產品變更通知  
Product Change Notice

No. 20240717

Inalways P/N(華瑋/力瑋)料號 0718-1-PQ-2BK/0718-1-PP-2BK/0718-1-PW-2BK/  
0718-1-PN-2BK/0718-1-PN-A-2BK

Before (變更前):

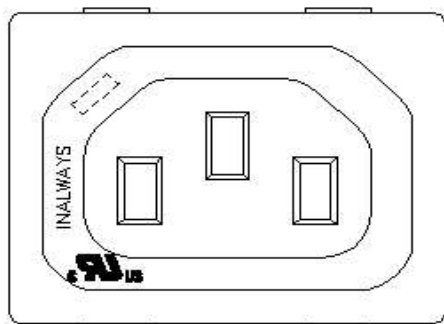
1. UL 测试升级，由原来 10A 250V~ 升级为15A 250V~。  
UL test upgrade, from the original 10A 250V ~ upgrade to 15A 250V ~。
2. 變更後的圖紙如附件  
The drawings are as attached files.
3. 變更刻字後的出貨將於 2024/10/01  
The marking changes shipment will be started from 2024/10/01
